REQUEST FOR INFORMATION (RFI)	
RFI # 1	SUBMITTED TO: Town of Golden Beach
DATE:	
NEEDED BY:	SUBMITTED BY: John Bell Construction
PROJECT: WELLNESS CENTER PROJECT	
PROJECT #: RFP 2024-002 (Wellness Center)	
RFI DESCRIPTION	
<ol style="list-style-type: none"> <li>1. Please refer to the "Material Specifications" Excel Document in the Contract Documents. Please confirm an Allowance (\$) for the Material Cost we are to carry in our Estimate for all the Material where "G.C." is shown in the "MANF." Column.</li> <li>2. During the 01/23/2025 Pre-Bid Meeting, it was said that an Addendum would be released confirming that all Exterior Aluminum Paneling (Alucobond, etc.) is to be removed from the proposed Plan and replaced with Stucco and Paint. Please confirm. Also, please confirm the same is true for the FRP Panels.</li> <li>3. Please confirm bidders are to provide a Bid Amount 100% PER PLAN, and a separate document showing Value Engineering/Alternate Cost Saving Options. We'd like to confirm we are not to include Value Engineered options in our Bid.</li> <li>4. Please confirm the Bid Due Date can be extended. We'd like to explore as many Value Engineering and Cost Saving Options as possibl

**17.5.3\* Detector Coverage.**

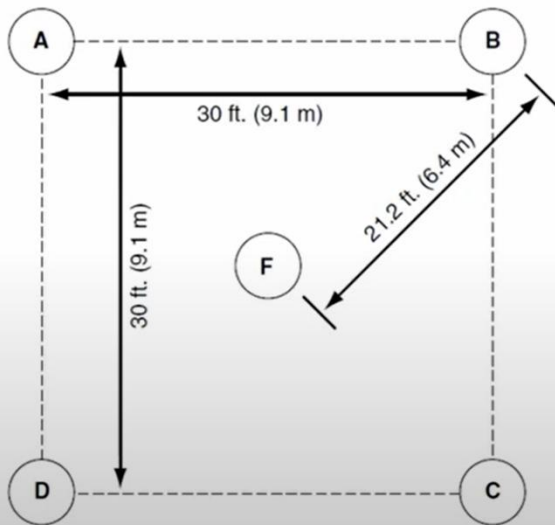
I have attached a set of mark-up plans showing some of the changes that I would like to propose to the fire alarm system in order to cut down on cost. I would also propose that we use the same model of fire alarm panel that we have installed in the Civic building as it has a lower cost impact and is manufactured by the same company as the fire alarm panel in the specs for this project. We have also located a few items that will be required but were not accounted for in the initial fire alarm bid set of plans that will have a minor cost impact, however to prevent future change orders I feel it is best to address these issues upfront rather than as a change order later. Just running through the rough figures on this project I believe that the system as shown on the bid set of plans is probably about 25% higher in cost than is necessary due to the excess smoke detector coverage.

The sprinklers are to control the spread of fire and protect the facility, but the smoke detectors are meant to give occupants in the area of the fire an early warning, so they can evacuate the area before the fire prevents them from doing so, especially in an area with children.

We have reviewed the code requirements and reduced the number of smoke detectors in line with the building code. See Addendum #2.

17.5.3.1\* **Total (Complete) Coverage.** Where required by other governing laws, codes, or standards, and unless otherwise modified by 17.5.3.1.1 through 17.5.3.1.5, total coverage of a building or a portion thereof, shall include all rooms, halls, storage areas, basements, attics, lofts, spaces above suspended ceilings, and other subdivisions and accessible spaces.
